ADDENDUM NUMBER 1
for
Oak Creek Water and Sewer Utility, Oak Creek Wisconsin

Pre-selection Documents
for the
Prestressed Concrete Storage Tank

DATE: April 27, 2015

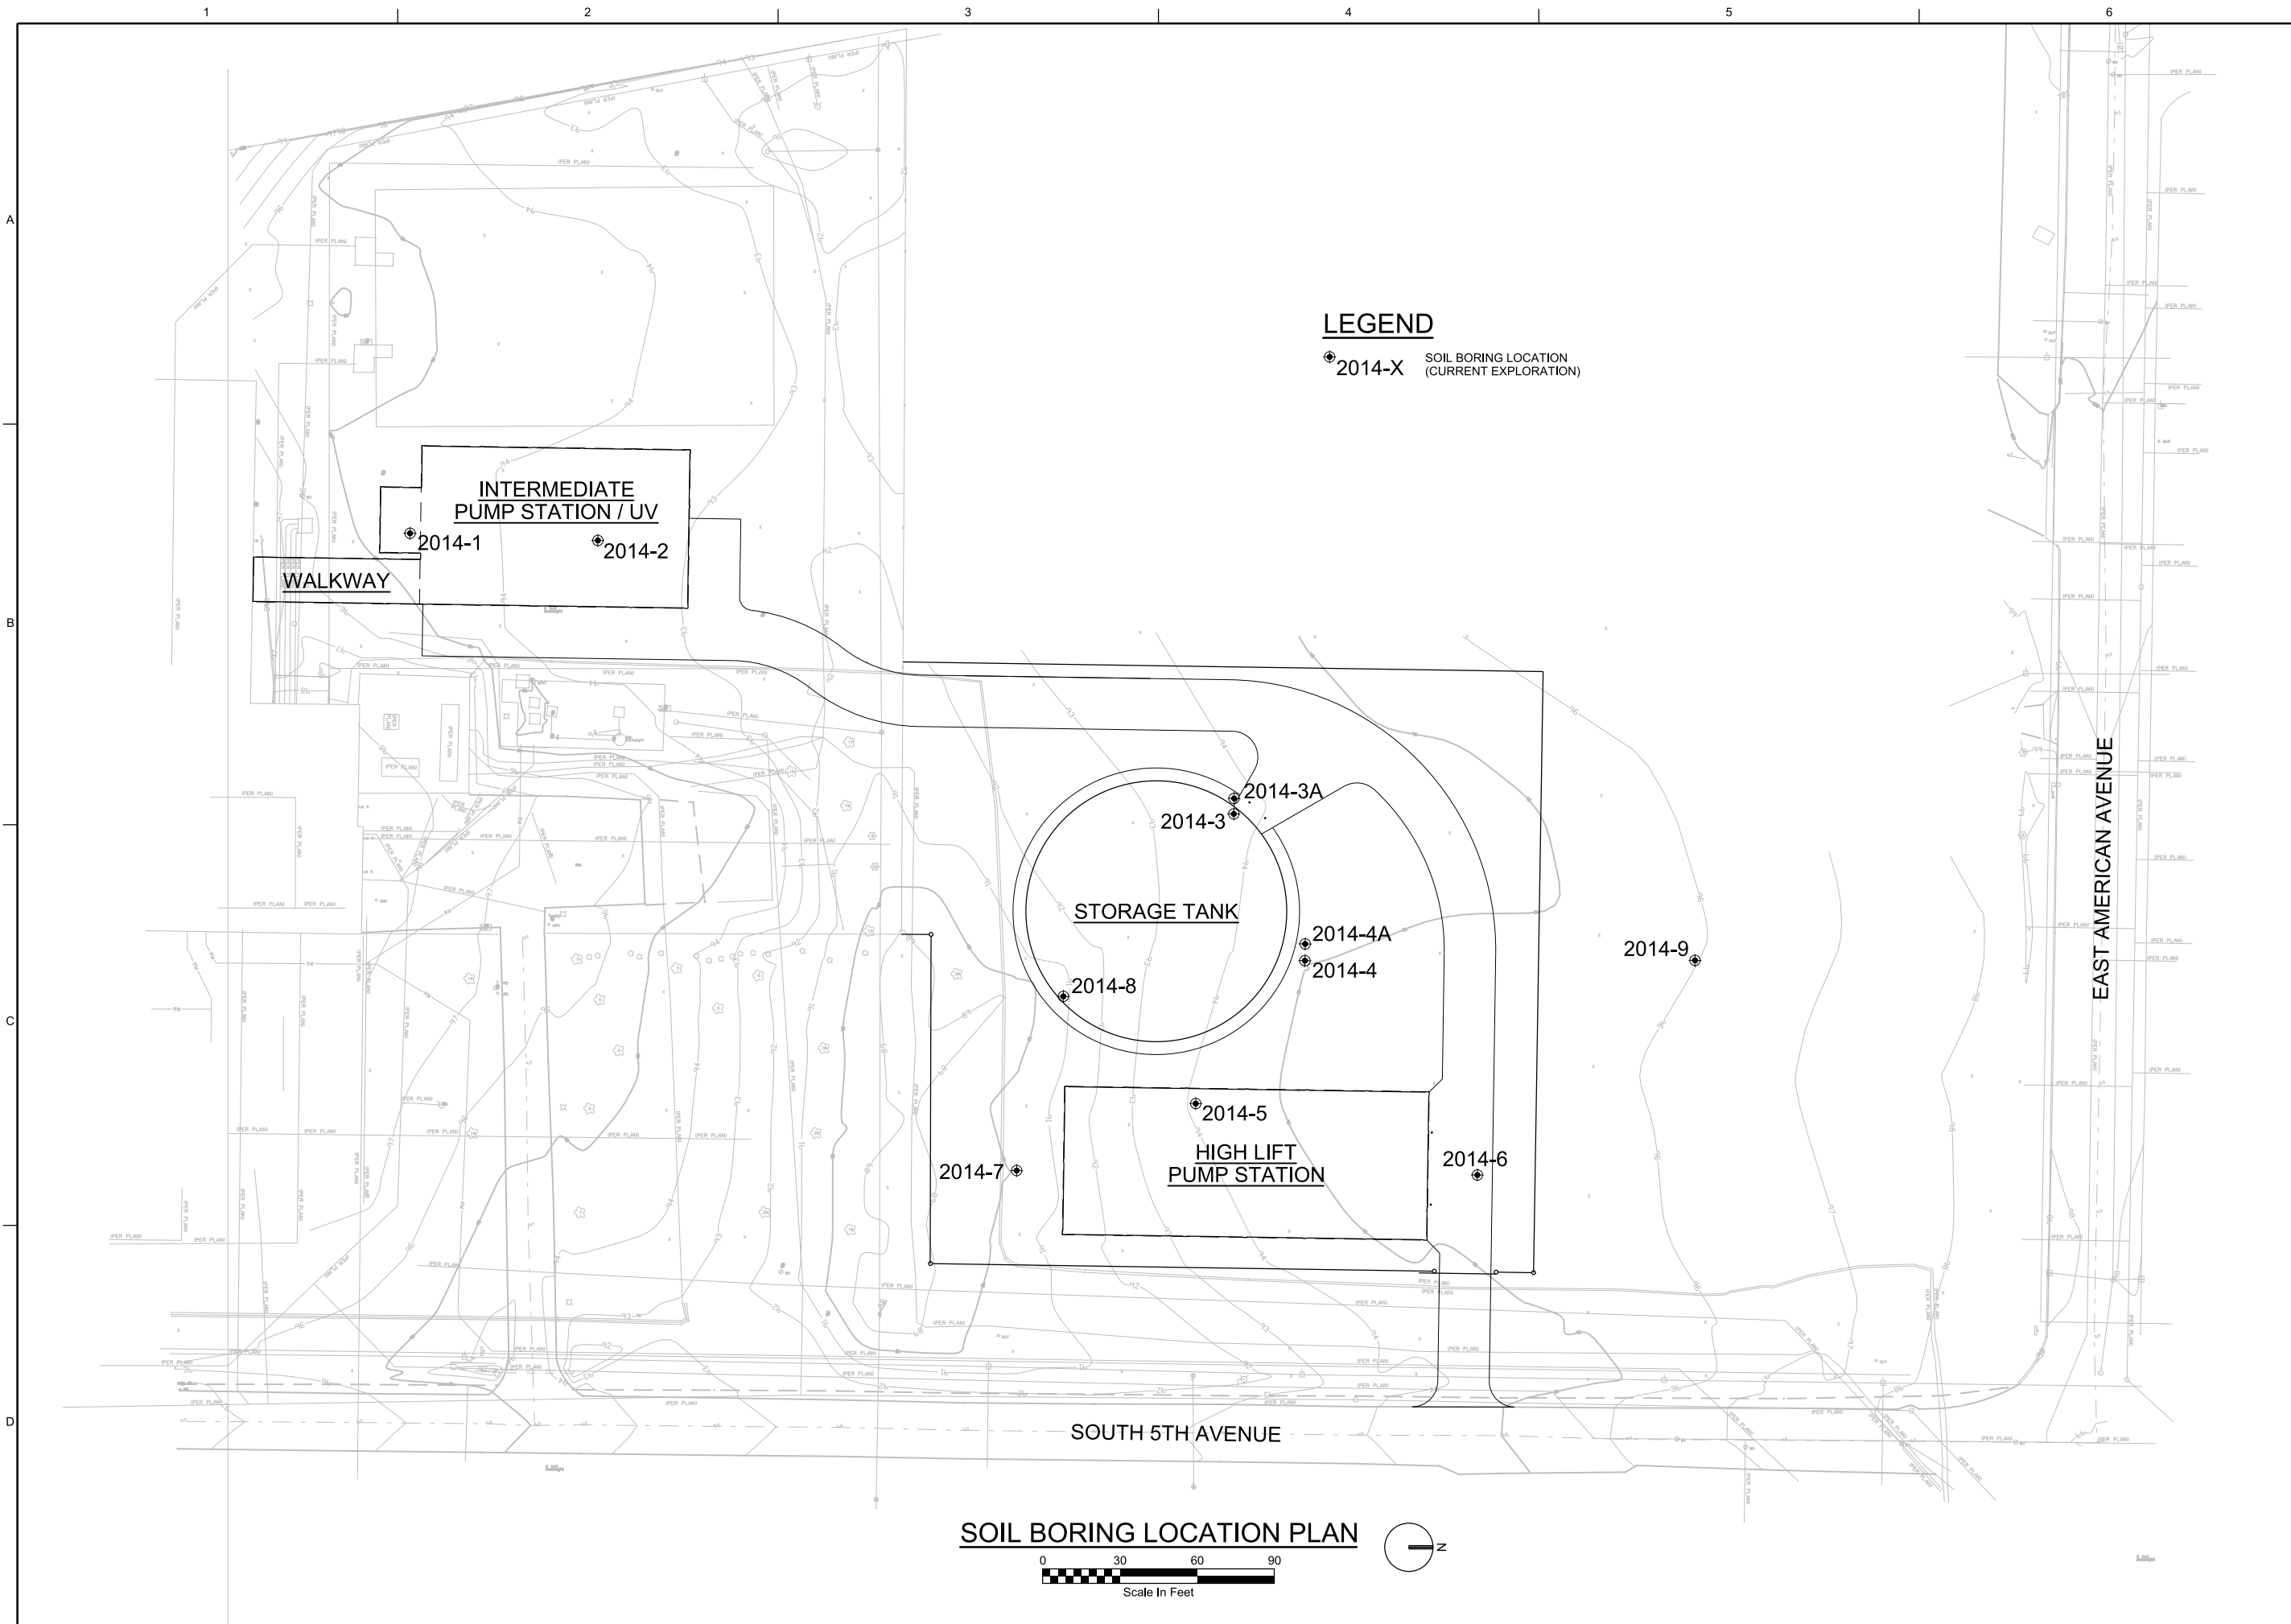
14. According to Table 3, Section 4.3 of the Geotechnical Report, the excavation elevation varies between 74' and 84', with a weighted average of 80'. We believe it advisable to excavate instead to a uniform elevation of about 80' in order to ensure uniform support conditions under the entire tank footprint. Please clarify.

A: Required over-excavation is necessary to remove compressible materials from the zone of influence of the tank. The materials slated for removal must be adequately removed and backfilled. The contractor may elect to remove additional material to form a fill of uniform thickness.

1/8"=1'-0"	
VERIFY SCALE	
BAR IS ONE INCH ON ORIGINAL DRAWING.	
DATE	MARCH 2015
PROJ	653463
DWG	40-SD-231
SHEET	of

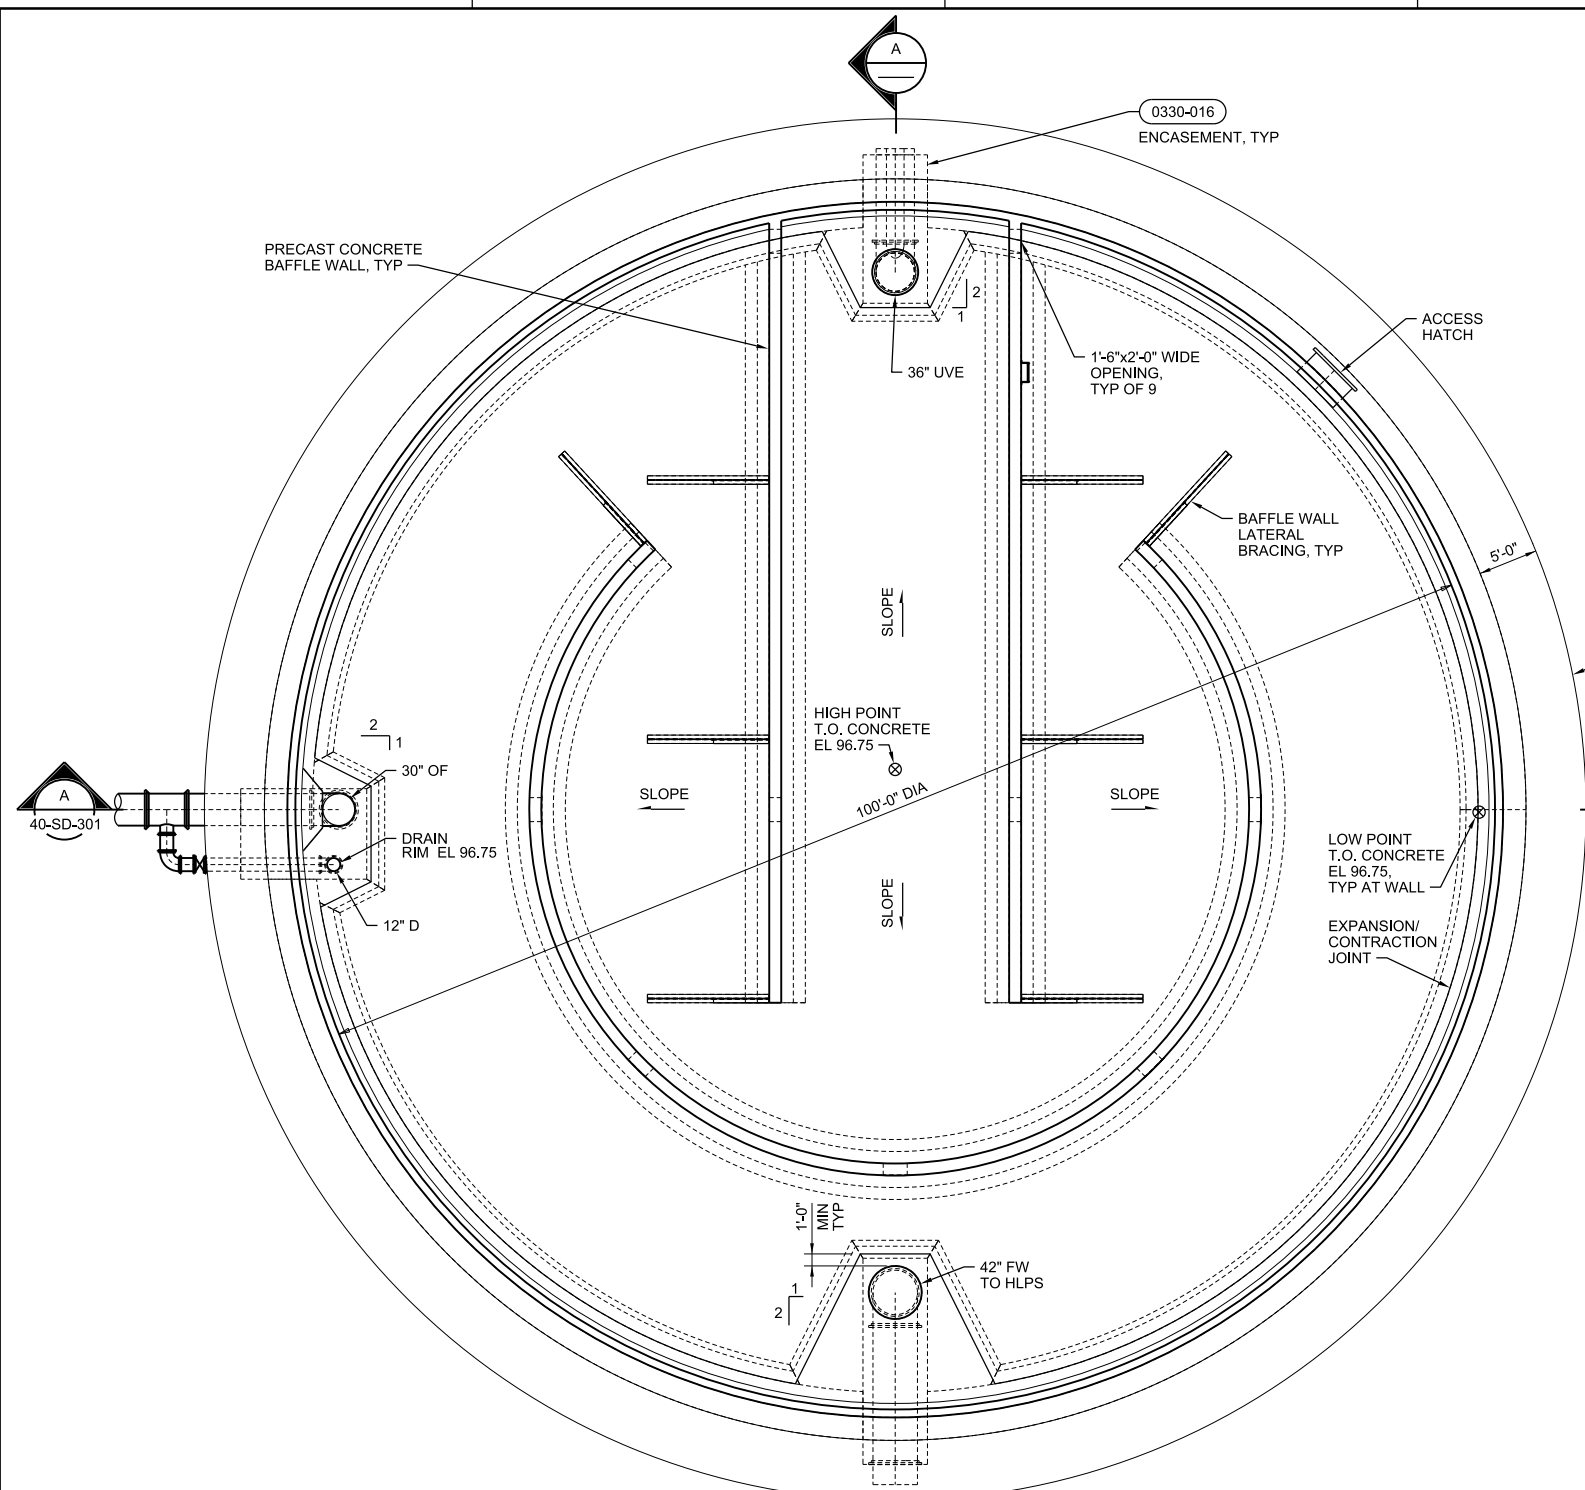
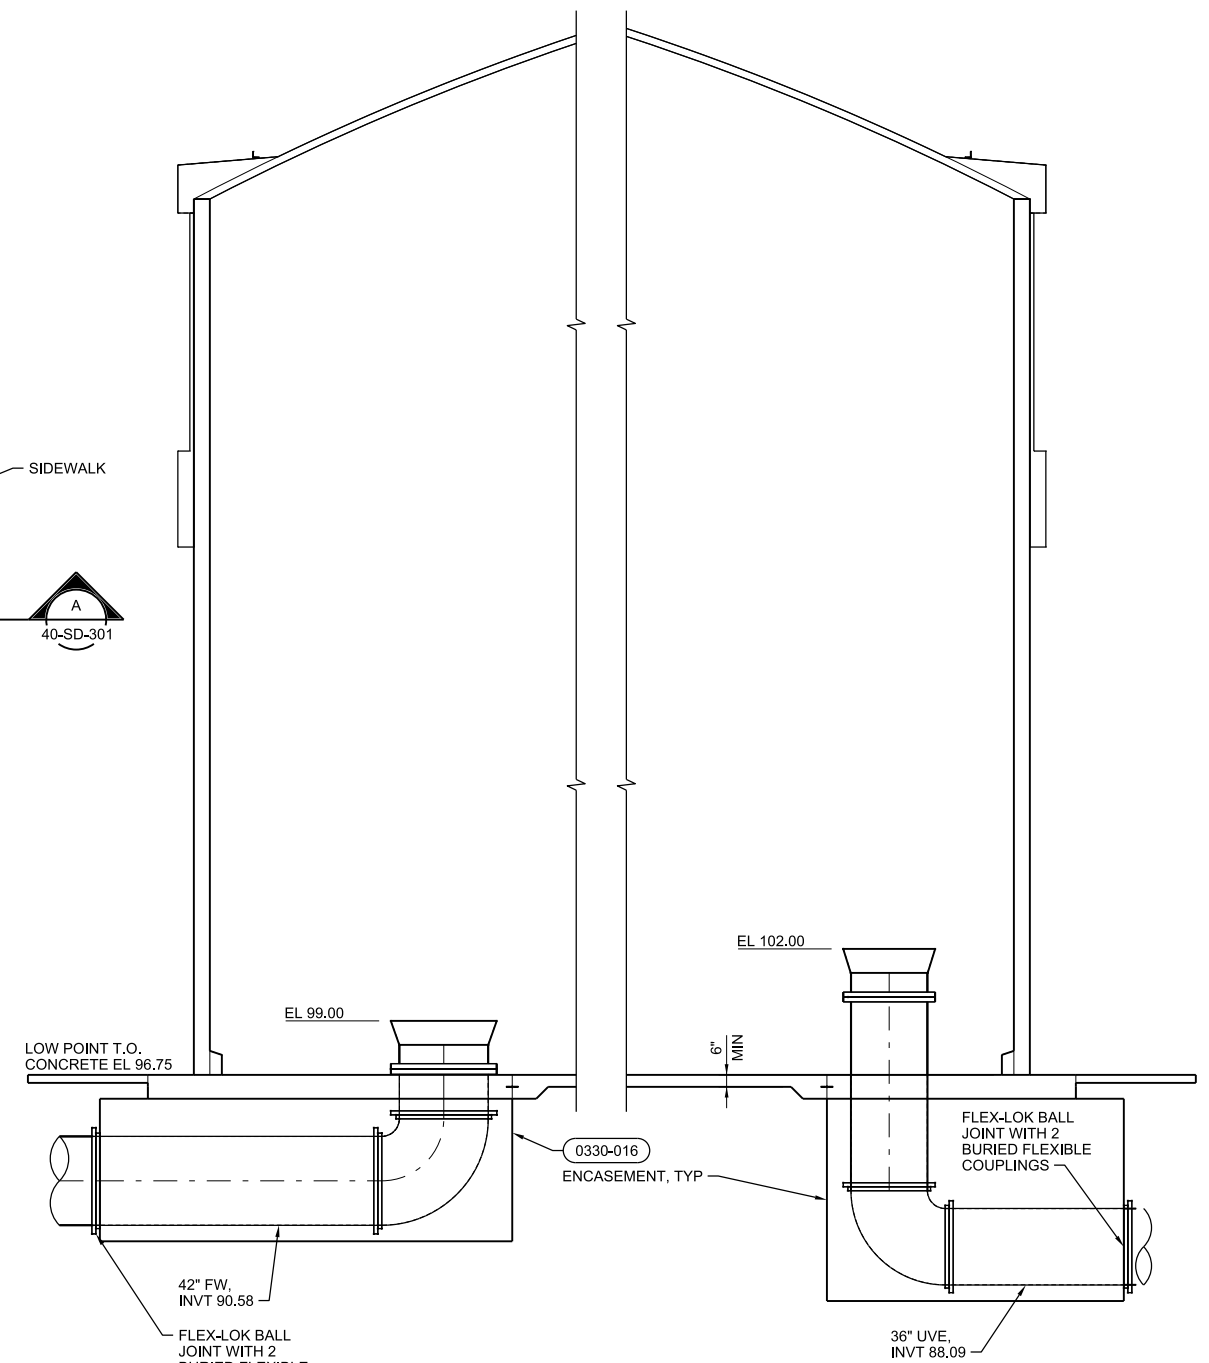
DRAWINGS 40-SD-231, 40-SD-301

1. Replace these drawings with attached revised drawings.

19. Drawing 40-SD-231 only shows an expansion joint for the 42" outlet pipe. Please clarify if an expansion joint is required for other underfloor piping such as inlet pipe, overflow pipe and drain.

20. Our normal practice in moderate to low seismic areas is to provide two flexible couplings, instead of expansion joints because of the anticipated movement under non-seismic loading is in the order of 3" +/- vertical and minimum along axis of the pipe as well as transverse direction. Accordingly, we recommend replacing one expansion joint with two flexible couplings. Is the acceptable? Please clarify.

A: See revised drawings.

A: See revised drawings.
